RE: Kramer Commerce Center Lot 3 (Cambridge Engineering): Site Development Section Plan, Landscape Plan, Lighting Plan and Architectural Elevations for a 2.858 acre site in a "PI" Planned Industrial District located at the Southeast corner of Long Road Crossing Drive and Spirit Drive North.

Kramer Commerce Center Lot 3 SDSP
Planning Commission Report
November 8, 2007

KRAMER COMMERCE CENTER - PROPOSED LOT 3
SITE DEVELOPMENT SECTION PLAN

PLANTING PLAN FOR THE PROPOSED LOT 3 - BUILDING B:
Kramer Commerce Center-Lot 3
 CHESTERFIELD, MISSOURI

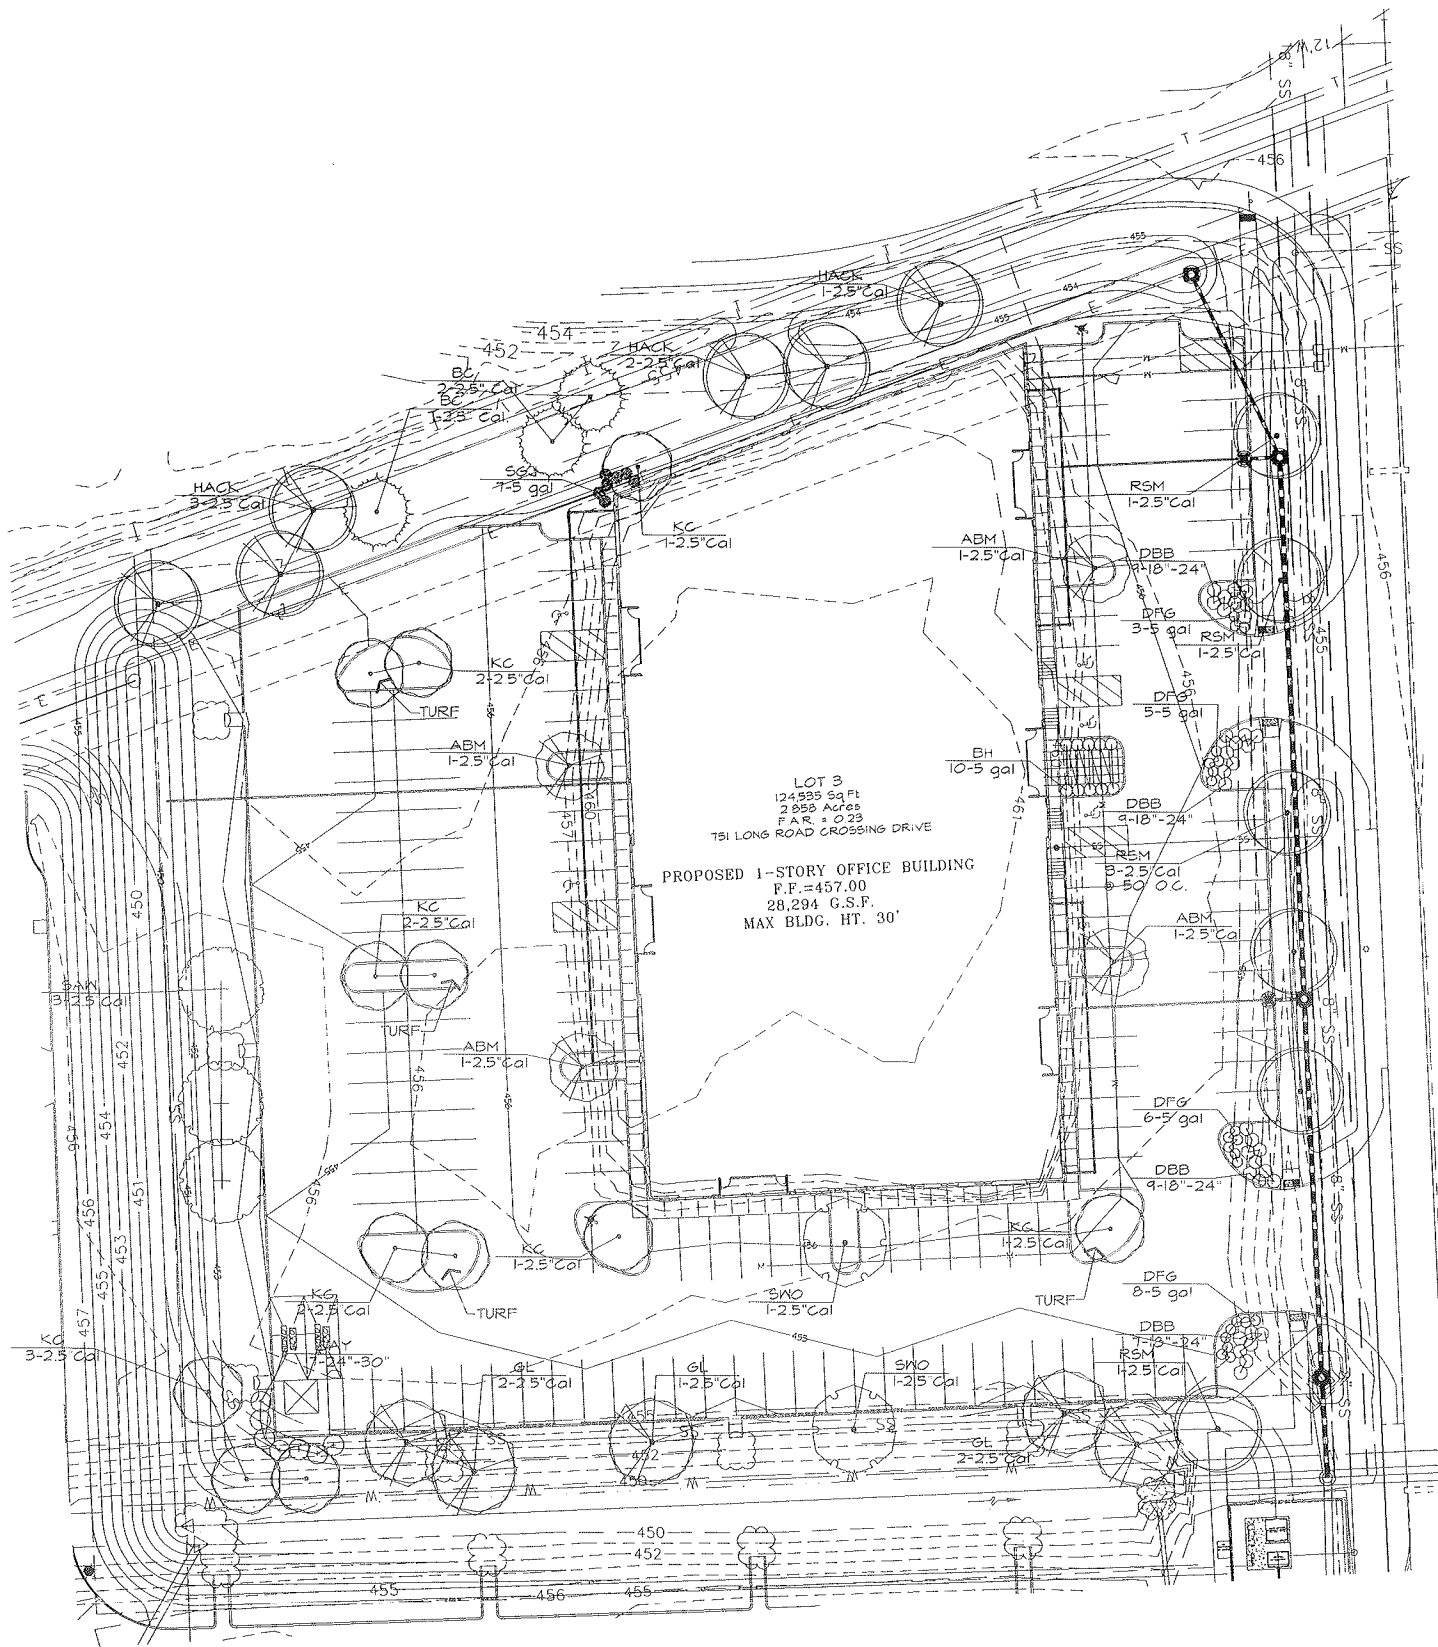
1. The trash enclosure screening to match the building materials and colors;
2. Addition of varied evergreen trees to the landscape plan; and
3. Provide safe pedestrian access throughout the site.

Through staff review and comments, the petitioner has addressed the Architectural Review Board recommendations
